To: Bidders for the *Oak Brook Park District- Central Park Improvements*

SUBJECT: ADDENDUM NO. 1 TO THE BIDDING DOCUMENTS FOR:
Oak Brook Park District – Central Park Improvements
Bid Group #1 Bid Packages 1 - 19

Project No. 07-5646-04

QUESTIONS AND ANSWER LOG

SD3.03

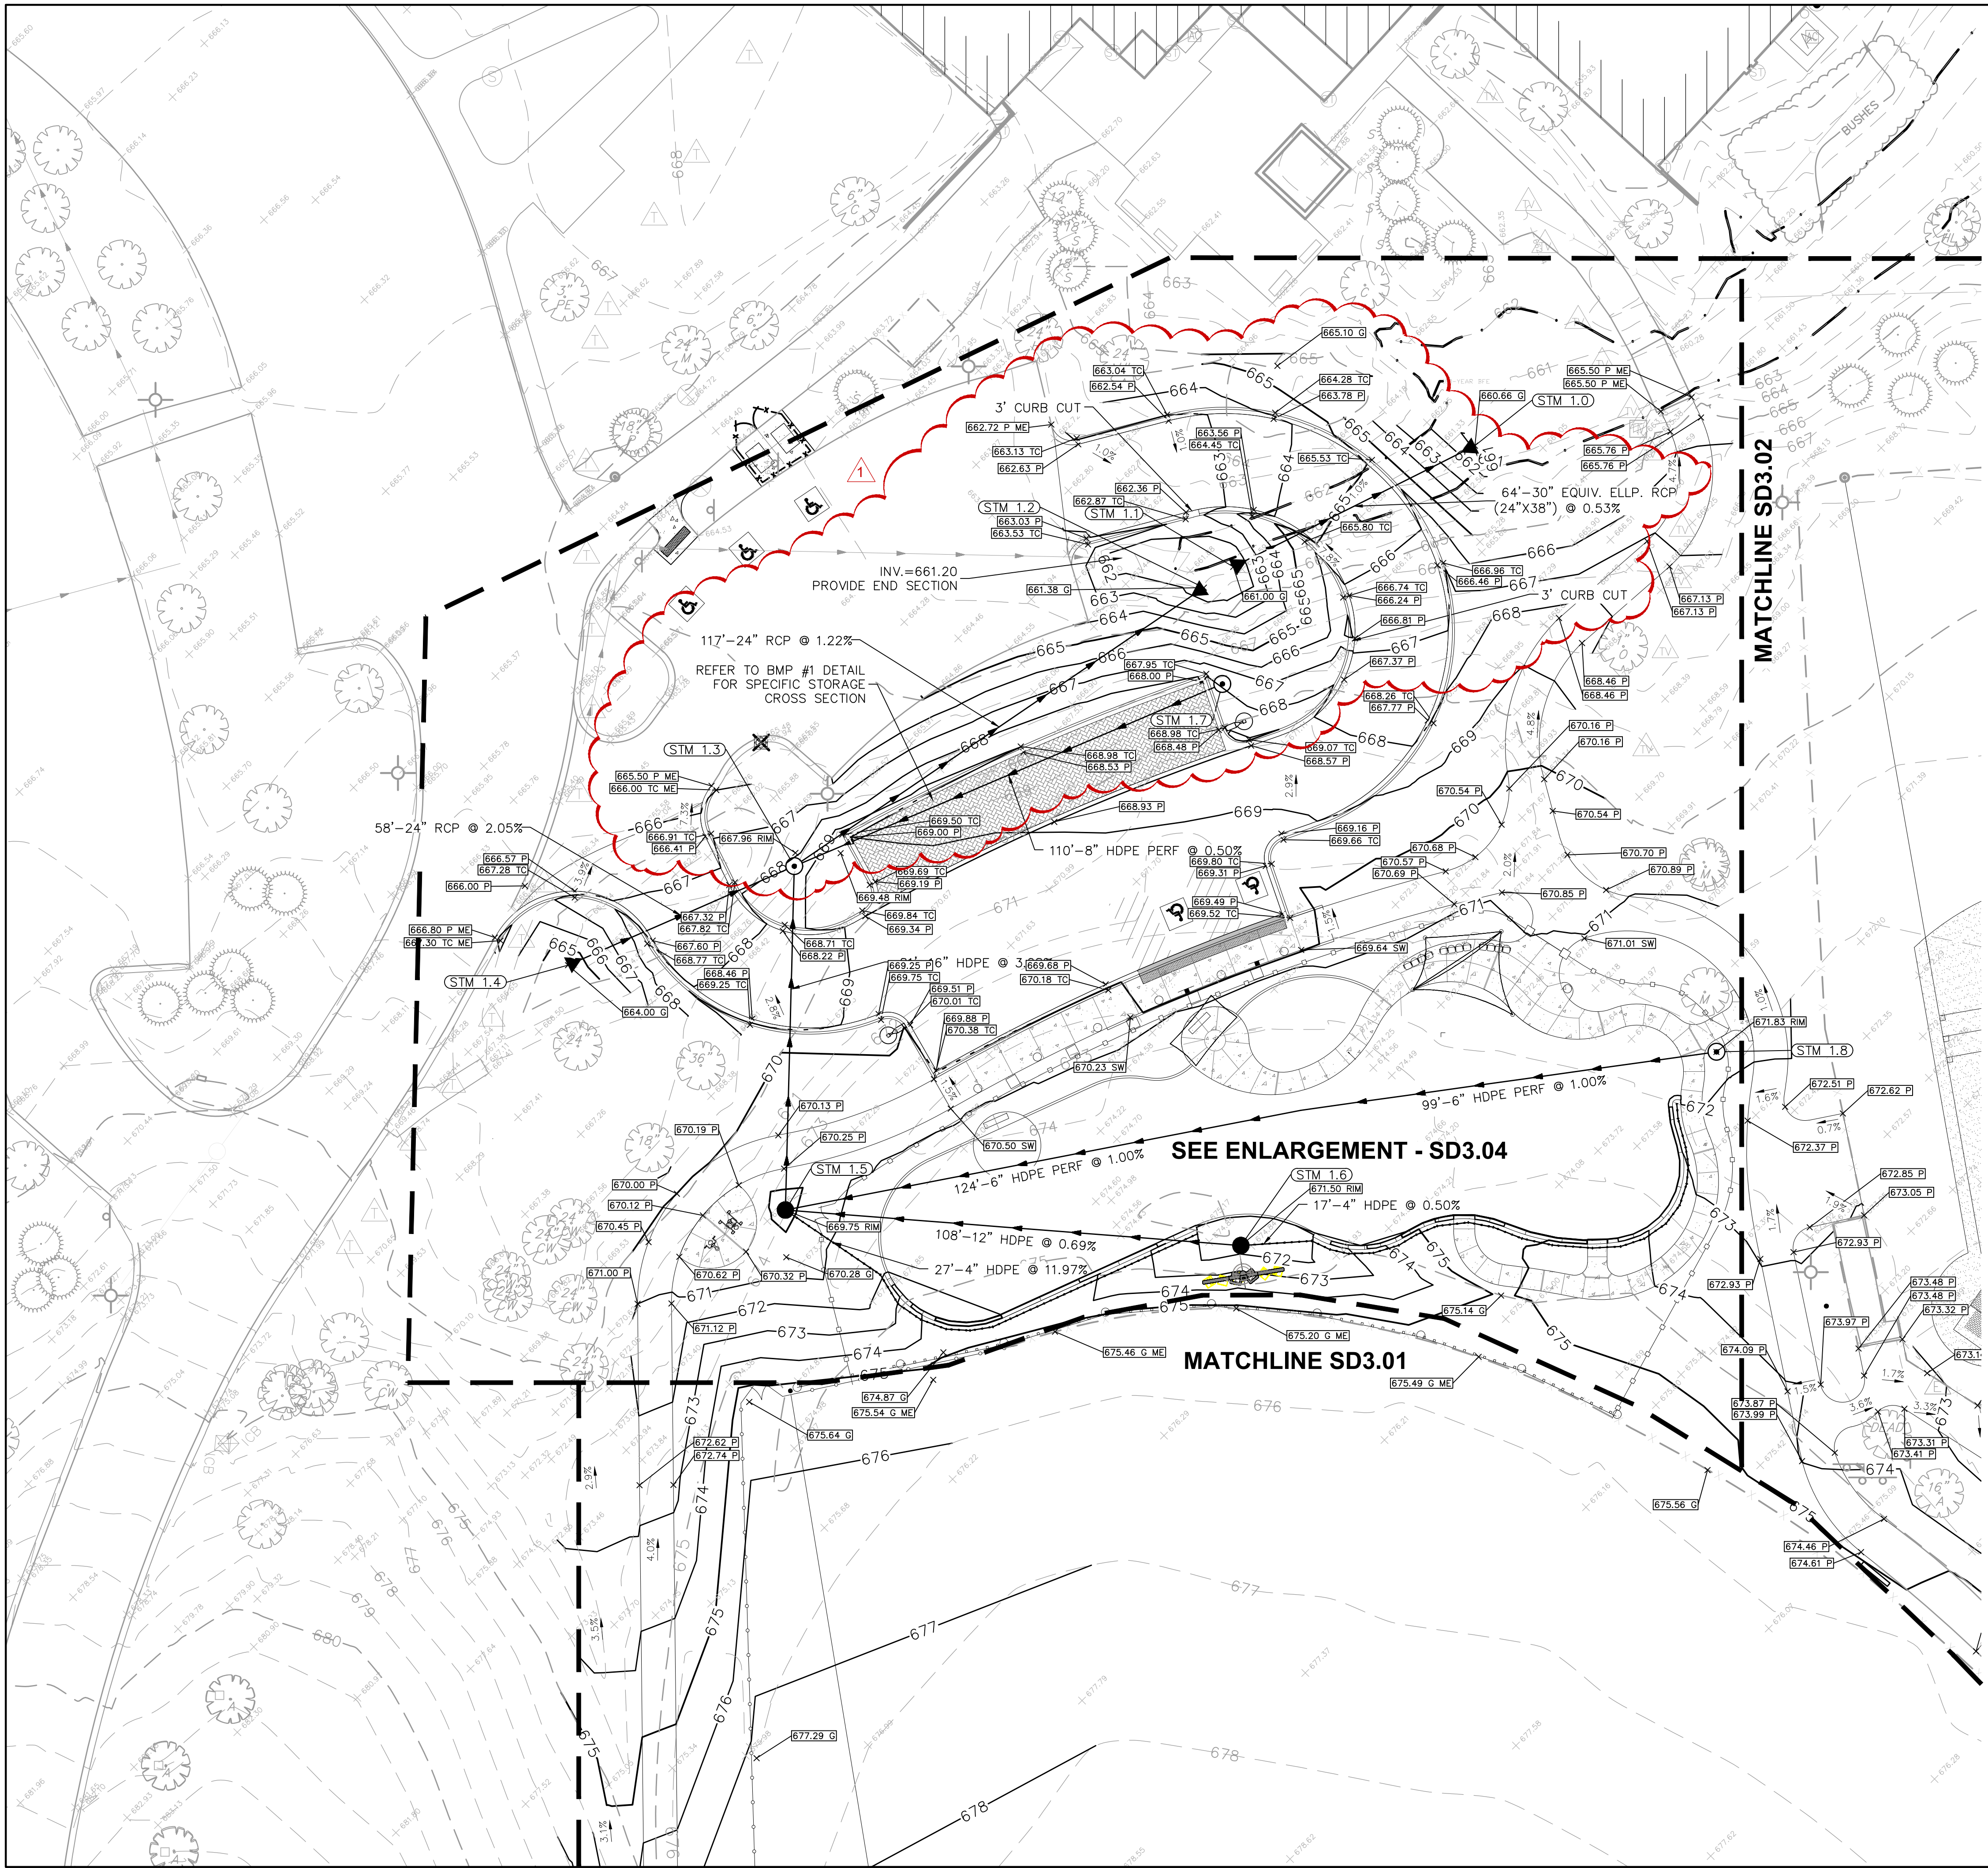
1. Storm Sewer and Structure Revisions. Revised inverts, pipe sizes, slopes and structure information.
2. Additional detail regarding paver underdrain, wall underdrain provided. All subgrades for paver areas shall slope at a minimum 0.50% towards underdrain locations.
3. Provided Additional spot shot details and updated grading.
4. Infield Grading shall be laser graded to provide positive drainage and be accurate.

SD3.05

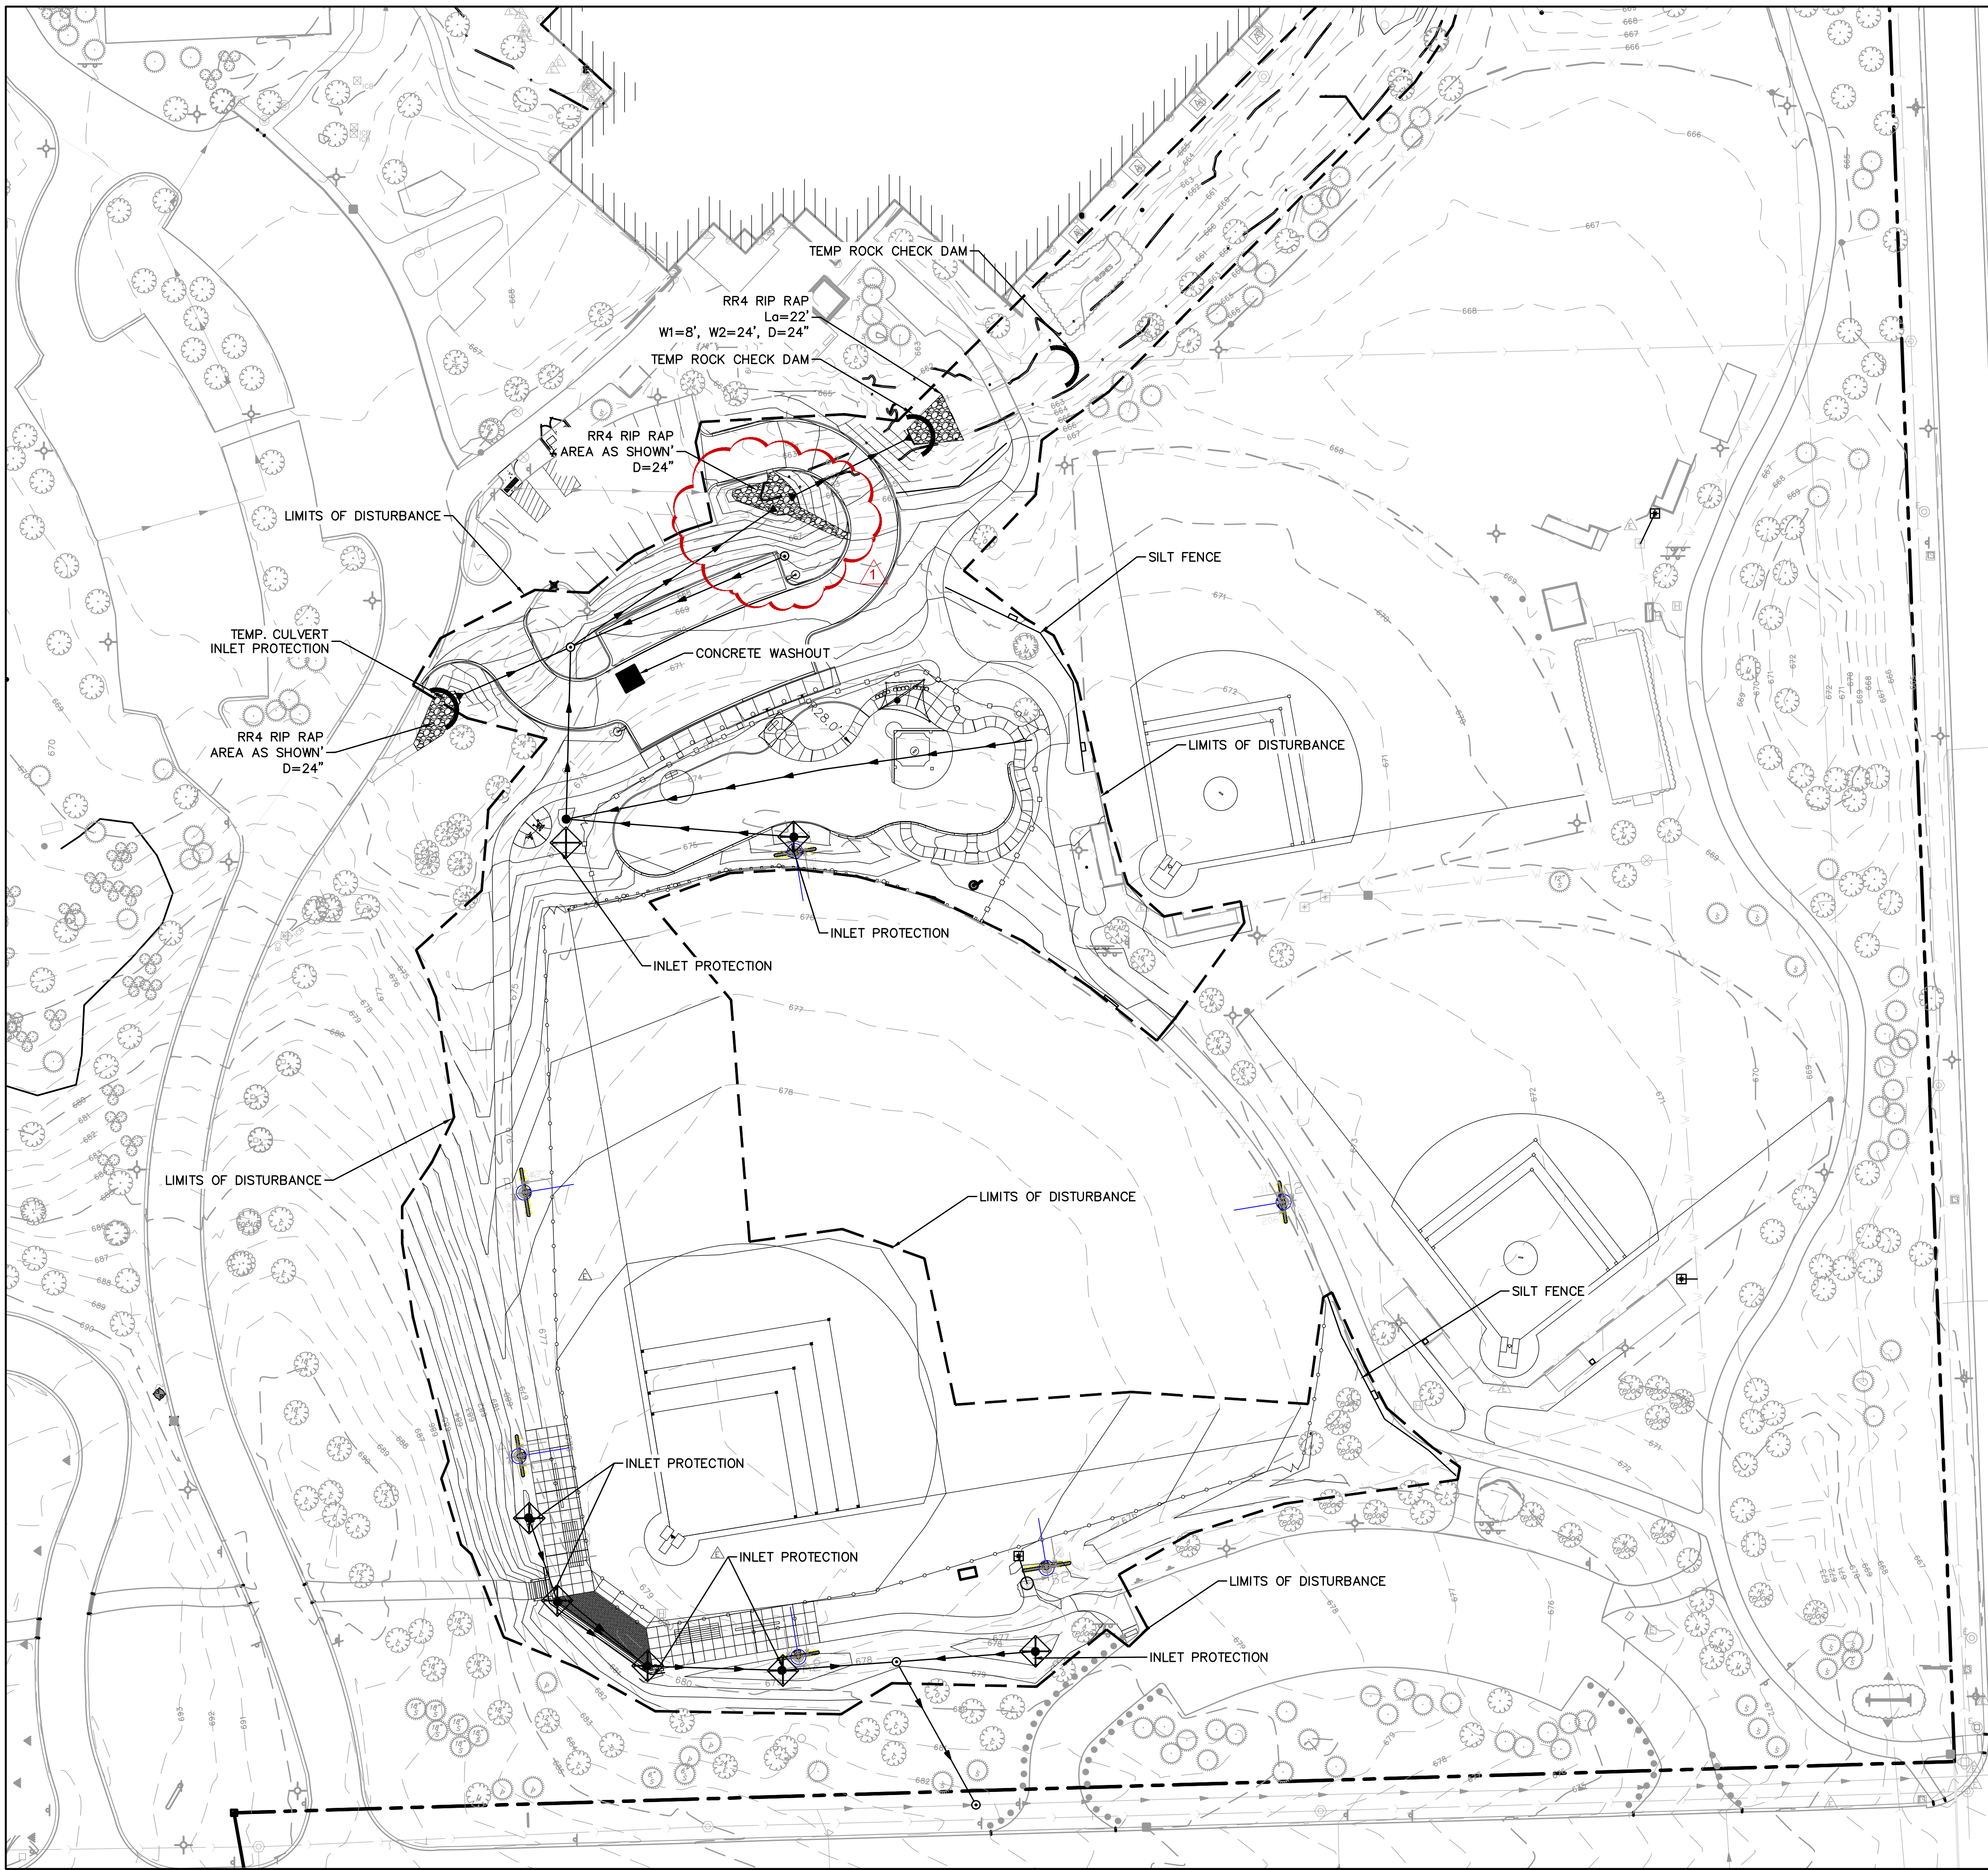
1. Provided Additional spot shot details and updated grading.

Sheet:
SD3.07

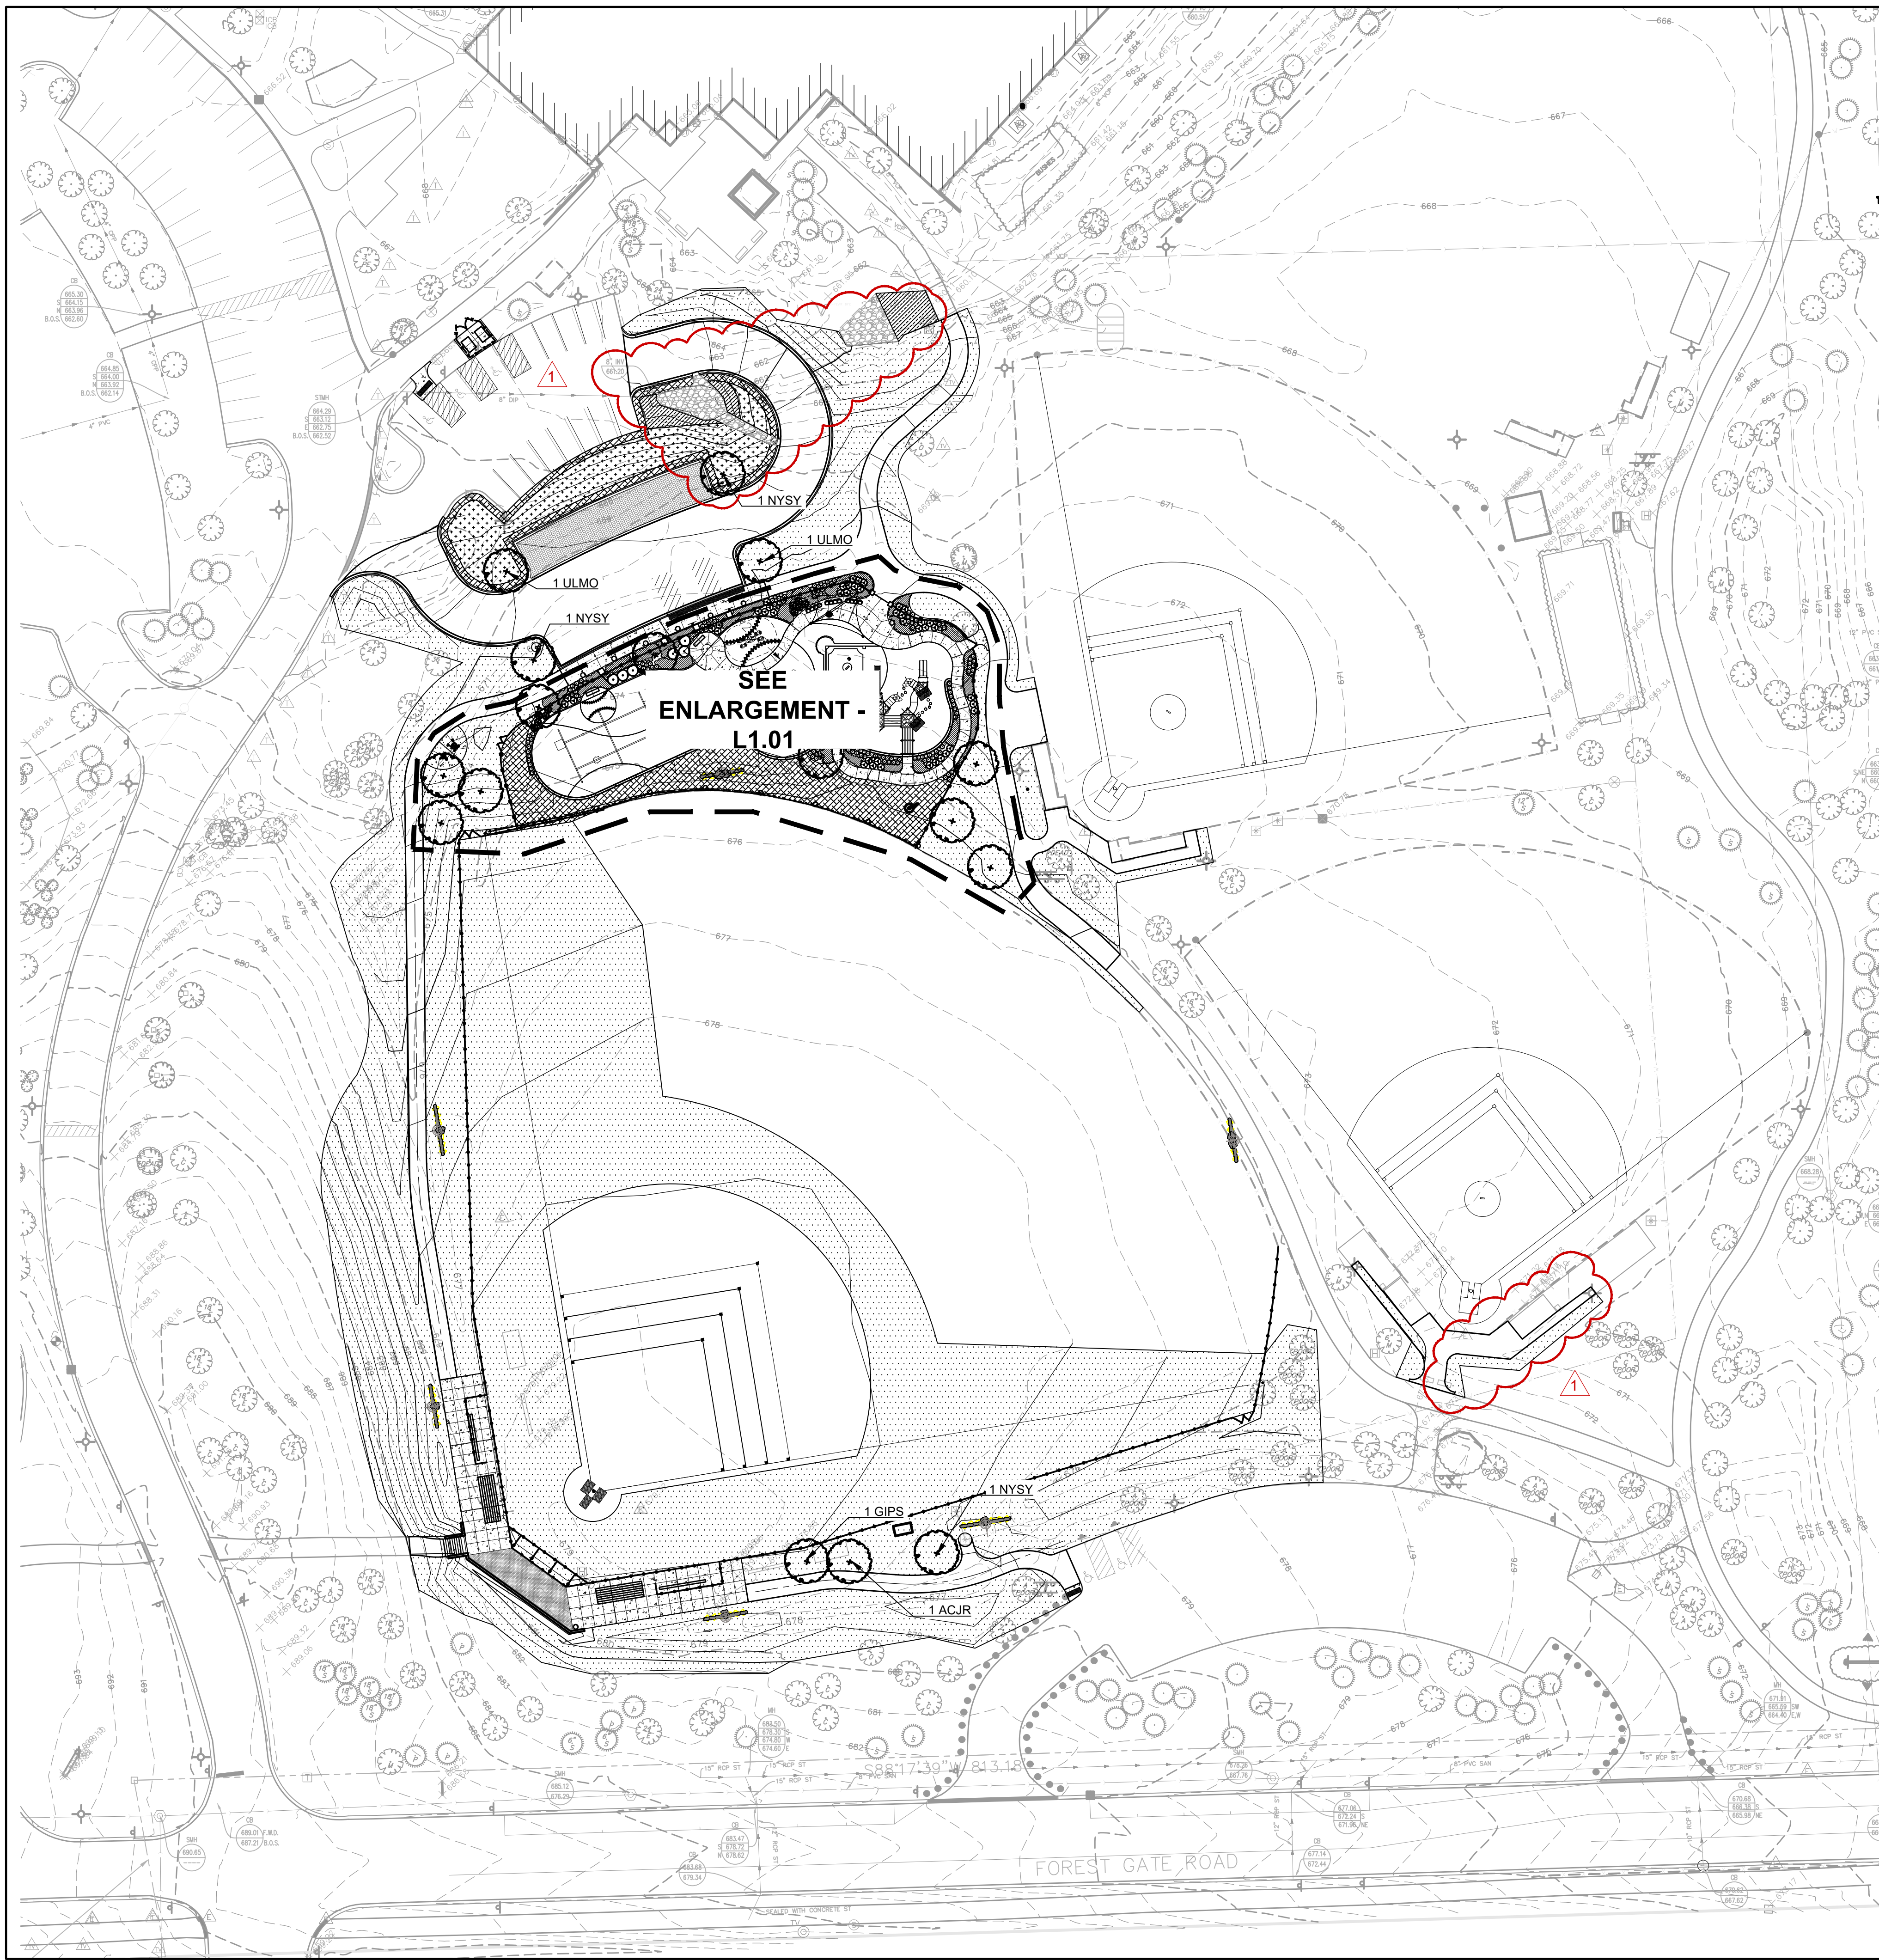
2. Rip Rap Layout revised at north parking lot area.
